INTERNATIONAL STANDARD

AMENDMENT 1

**Digital audio – Interface for non-linear PCM encoded audio bitstreams applying IEC 60958 –
Part 5: Non-linear PCM bitstreams according to the DTS (Digital Theater Systems) format(s)**

Figure 7 – DTS type IV single burst mode

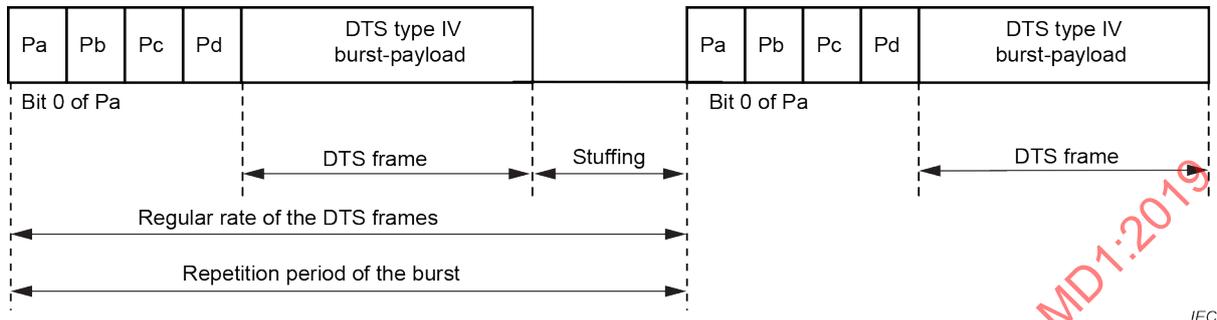
Move Figure 7 from 5.3.4 to this position in 5.3.5.1, and replace the existing Figure 7 with the following new Figure 7:

DTS type IV profile 0 shall deliver a DTS audio frame in a each burst. The burst repetition period, indicated with bits 8 – 10 of Pc, is relative to the period of the IEC 60958 frame. Figure 7 provides a representation of the repetition period of the burst.

NOTE 1 The length of the DTS type IV data-burst depends on the encoded bit rate and duration of the burst.

Figure 8 – Decoder latency of DTS type IV single burst mode

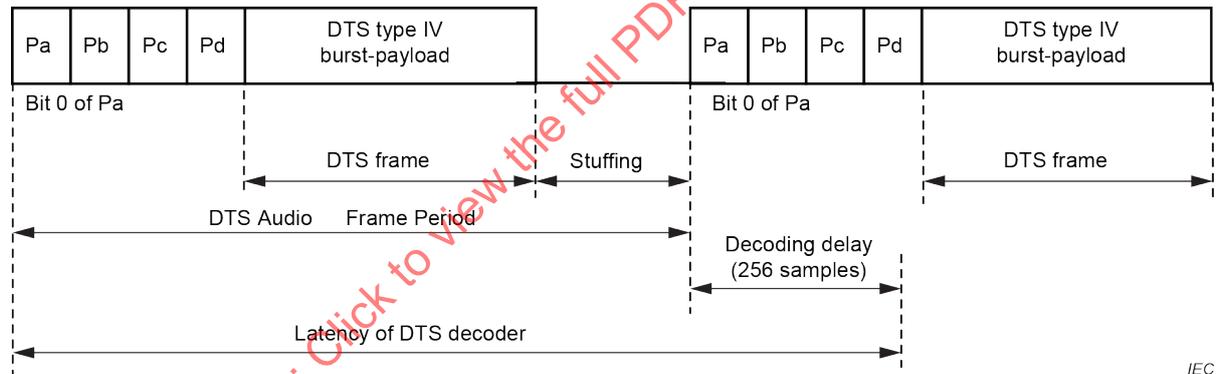
Move Figure 8 from 5.3.4 to this position in 5.3.5.1, and replace the existing Figure 8 with the following new Figure 8:

NOTE 2 The latency of a DTS decoder is defined as a delay measured from the reference point, and equal to one frame (10,67 ms) plus one subframe (256 samples at 48 kHz, or 5,33 ms), equivalent to 16 ms.

Figure 9 – DTS type IV multi-burst mode

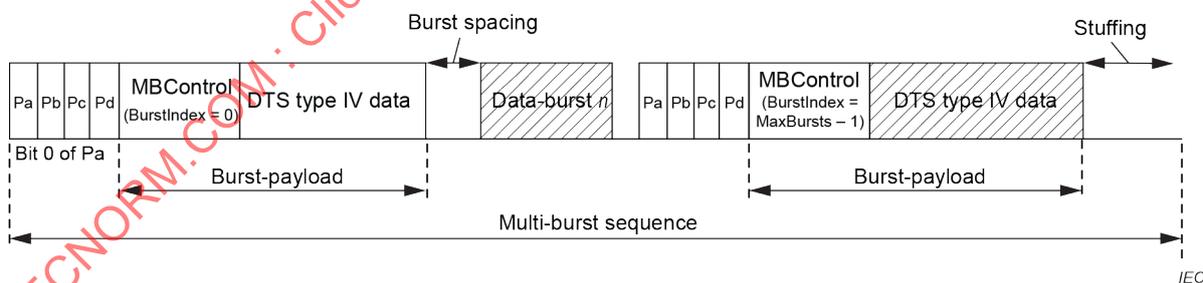
Add the following new Figure 9:

A representation of a multi-burst sequence is shown in Figure 9. This representation assumes the case of 2 or more data-bursts per multi-burst sequence, and any data-bursts between the first and last data-burst are represented as data-burst *n*.

Figure 10 – Decoder latency for DTS type IV multi-burst mode

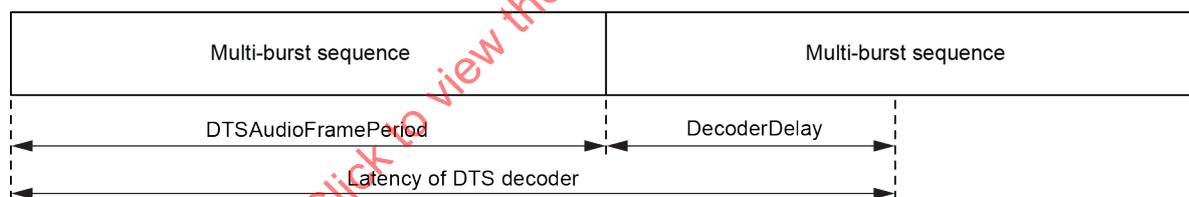
Add the following new Figure 10:

Decoder latency for audio delivered using multi-burst mode is illustrated in Figure 10.
